Staff Report

Report To:	Planning and Development Committee		
Date of Meeting:	January 22, 2024	Report Number:	PDS-001-24
Submitted By:	Carlos Salazar, Deputy CAO, Planning and Infrastructure Services		
Reviewed By:	Rob Maciver, Deputy CAO, S	olicitor Resolution#:	
File Number:	PLN 34.5.2.9 HPA2023-011	By-law Number	:
Report Subject:	Proposed Heritage Permit Application; Alterations to Designated Heritage Property: 6966 Highway 35/115 Kirby Church, Kirby (Designation By-law 96-164)

Figure 2: Kirby Church at 6966 Highway 35/115

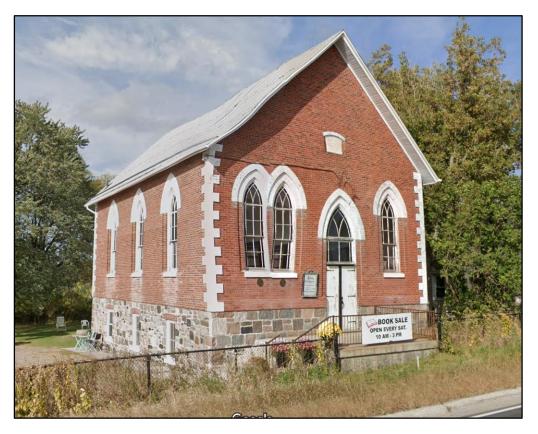
- 3.1 The lancet windows, including those with panes of original coloured glass, are heritage attributes recognized in the designation by-law as having heritage significance. Some windows shattered in the spring of 2023 due to the weather, and some were damaged by vandalism. The owner is seeking to replace the windows and frames on the main floor to address the issue. Details about the proposed style of window, materials and grill patterns were provided. The replacement windows will be designed so as to fit within the existing window frame and have a similar style and appearance to the originals, with the exception of the stained glass, the effects of which would be mainly experienced from within the building.

4.1 Staff has reviewed the proposal and consulted with the CHC to assess the proposed work and expected impacts on the protected heritage features of the building as listed above. The proposal involves the replacement of windows and frames. The original coloured glass will not be preserved or restored due to the cost. Staff and the CHC are of the opinion that the alteration of the designated attribute is necessary and brings the building into a state of good repair, thereby contributing to its long-term conservation.

- 1. That Report PDS-001-24 be received;
- That Heritage Permit Application No. HPA2023-011 to allow for the replacement of windows on the main floor of the Church building at 6966 Highway 35/115, Kirby Church, be approved, subject to the following conditions: provided the replacement of windows and frames in a similar style to the originals and are compatible with the building and in accordance with applicable Designation By-law 96-164, and Section 33(4) of the Ontario Heritage Act, R.S.O. 1990, Chapter 0.18; and
- 3. That the Ontario Heritage Trust, the Clarington Heritage Committee, the property owners, and all interested parties listed in Report PDS-001-24 be advised of Council's decision.
